XtremeAir GmbH, Harzstr.2, D-39444 Hecklingen Tel: +49 39267 60999 0, Fax: +49 39267 60999 20 www.xtremeair.de info@xtremeair.de	Document No. SB-XA42-2018-009
		Issue: A.00
DOA-Nr.: EASA.21J.360	Service Bulletin	Date: 05.04.2018

Subject: Smoke oil refill limit switch

Aircraft type affected: XA41 and XA42

Figure 1: Position of the dia. 12mm hole for the smoke oil limit switch

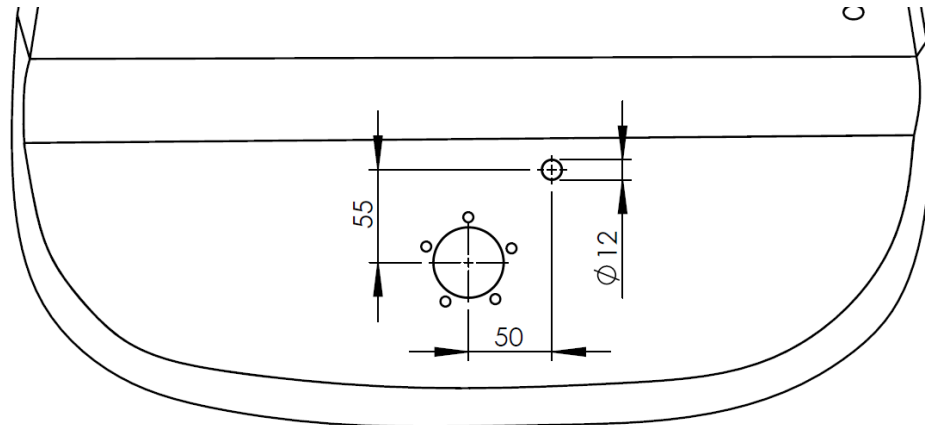
10. Drill a hole with dia. 12mm in the smoke tank shell. Refer to Figure 1 for the correct position.
11. Clean the inner and outer smoke tank from shavings.

Figure 2: Position of the smoke relay, left: XA41 ; right: XA42

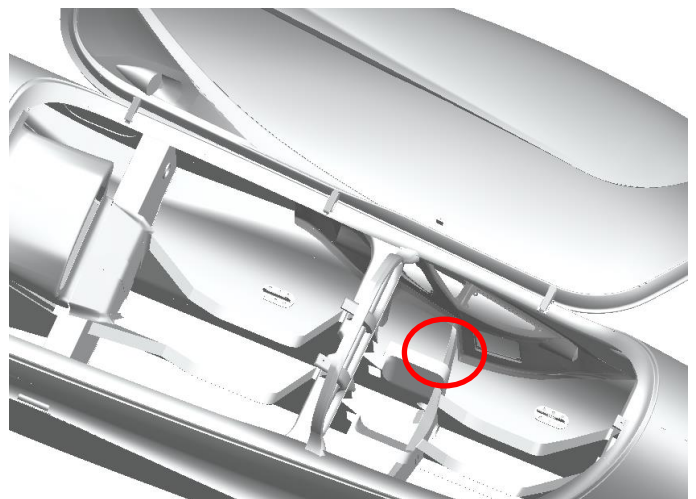
14. For XA41 only:
 1. Identify the smoke relay on the RH seat frame. Refer to Figure 2.
 2. Clean the area aft of this relay with alcohol.
 3. Bond the 8-32 EZ point stud on the RH seat frame with a distance of 50mm aft of the smoke relay using Araldite 2022-1. Refer to the manufacturer's bonding instructions for further handling information.

15. For XA42 only:
1. Identify the smoke relay on the RH side of the lateral frame under the rear seat. Refer to Figure 2.
 2. Clean the area left of this relay with alcohol.

Figure 3: Smoke system wiring XA41/XA42

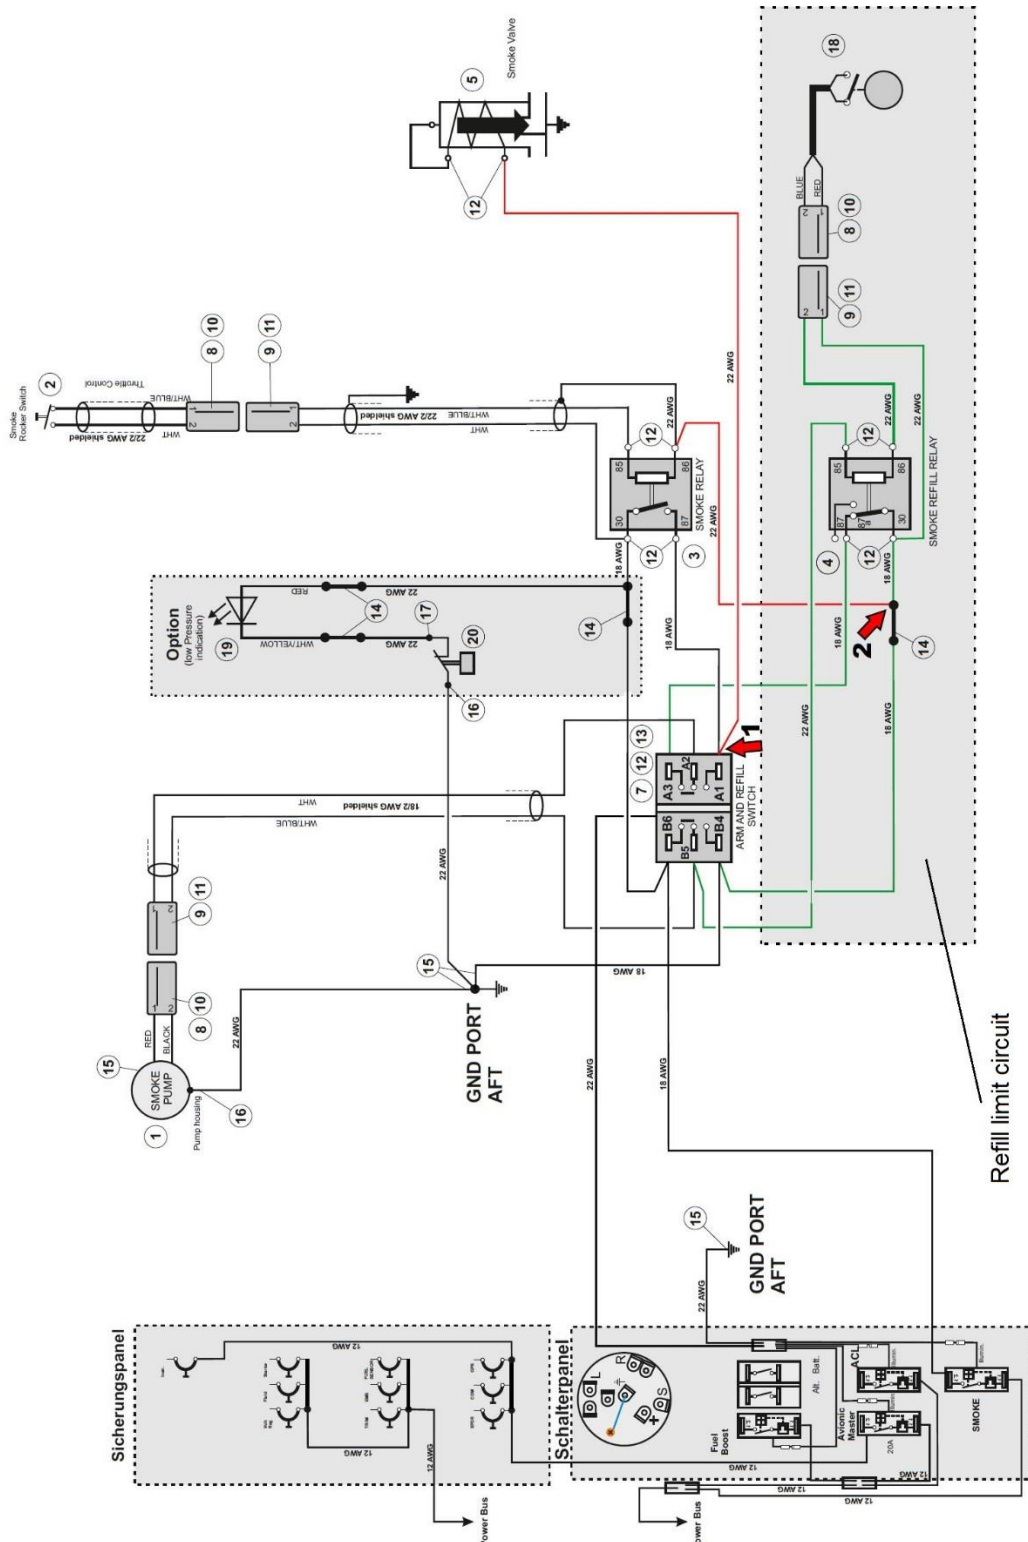
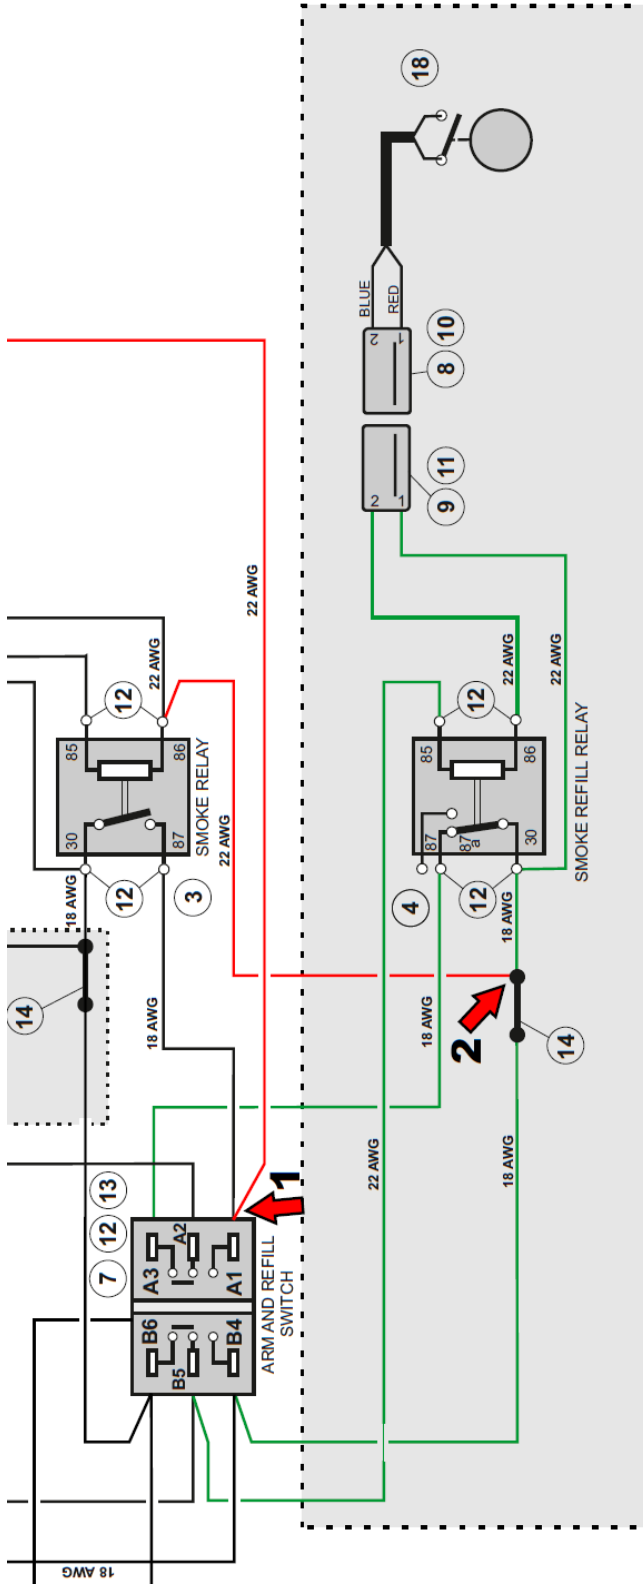
16. Make the cable connections as shown in the wiring diagram from Figure 3 and 4.
Points to consider:
- red marked wires must be reconnected (see red arrows)

- green marked wires stand for new connections
17. Cover all open electrical connections with liquid tape.
 18. Reassemble and reconnect all items in reverse order.
